BULLETIN: CA-SB-17-73-23

SERVICE BULLETIN

17DA JOURNAL BEARING LINER

To advise of a change in the seal and drive end bearing liners in the 17DA compressor.

Figures 1 and 2 illustrate the change.

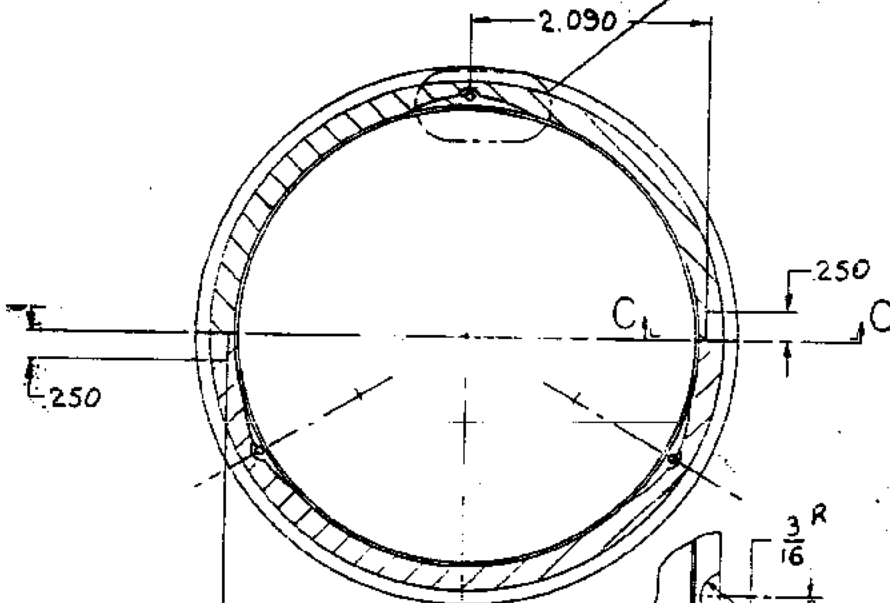
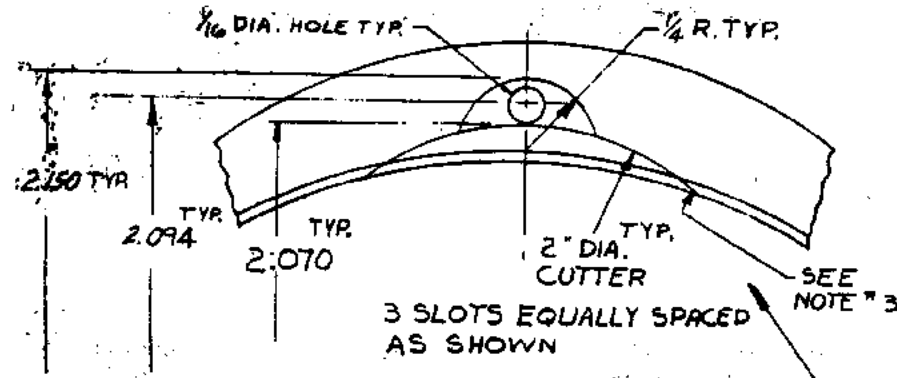
In order to improve control of oil flows and pressures in 17DA compressors, a change has been made to the journal bearing liners. The three oil relief slots have been eliminated and three drilled holes (1/16" diameter) have been added to replace them.
